APPLICATION NO.	FILING DATE	FIRST NAMED INVENTOR	ATTORNEY DOCKET NO.	CONFIRMATION NO.
10/596,957	06/30/2006	Norman E. Wandke	US040029US2	8971
24737 7590 08/05/2009 PHILIPS INTELLECTUAL PROPERTY & STANDARDS P.O. BOX 3001 PRIADCH HE MANOR NV 10510			EXAMINER	
			THOMAS, COURTNEY D	
BRIARCLIFF MANOR, NY 10510			ART UNIT	PAPER NUMBER
			2882	
			MAIL DATE	DELIVERY MODE
			08/05/2009	PAPER

DETAILED ACTION

Figs. 1-3, X-ray tube - U.S. Patent 7,209,546 to Arnold et al.

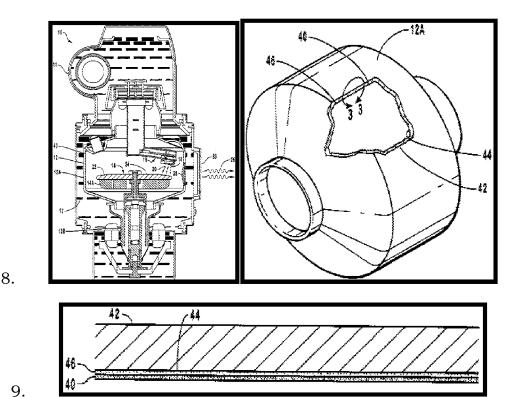
- As per claims 1, 17 and 20, Arnold et al. disclose an X-ray tube (10) 10. comprising: an outer housing (11) surrounding at least a portion of the X-ray tube and containing a cooling fluid (17), a frame (12) which encloses an evacuated chamber (col. 6:61-63); an anode (14) disposed within the evacuated chamber; the frame (12) including a vessel which surrounds the anode (14), the vessel being defined by a combination of: a material (42 - see also col. 7:66 -8:1) with high thermal conductivity and lower deformation resistance (relative to a second) material (40 - see also col. 8:58-61) with a high deformation resistance and lower thermal conductivity. [Examiner note: material (42) - Cu -Thermal conductivity ~400 W/mK; Yield strength ~ 714 kg/cm2; material (40) - Ti/ Titanium alloy(s) - Thermal Conductivity ~22 W/mK; Yield Strength ~ 2800 - 9007 kg/cm2 (range includes titanium alloy values); For purposes of examination, Examiner equates element (42) as a "thermally conductive liner" and element (40) as a "structural framework" - the noted properties of the elements are considered to provide the functional limitations of the claims (thermal conductivity and deformation resistance)].

- 11. **As per claims 18 and 21**, Arnold et al. disclose a method comprising the step(s) of: conducting heat away from an evacuated chamber through a liner (42) formed from a thermally conductive material and restraining the liner against deformation with a structural framework (40) see for example Figs, shown above; see also Examiner note above and respective portions of Arnold et al. (not shown above)).
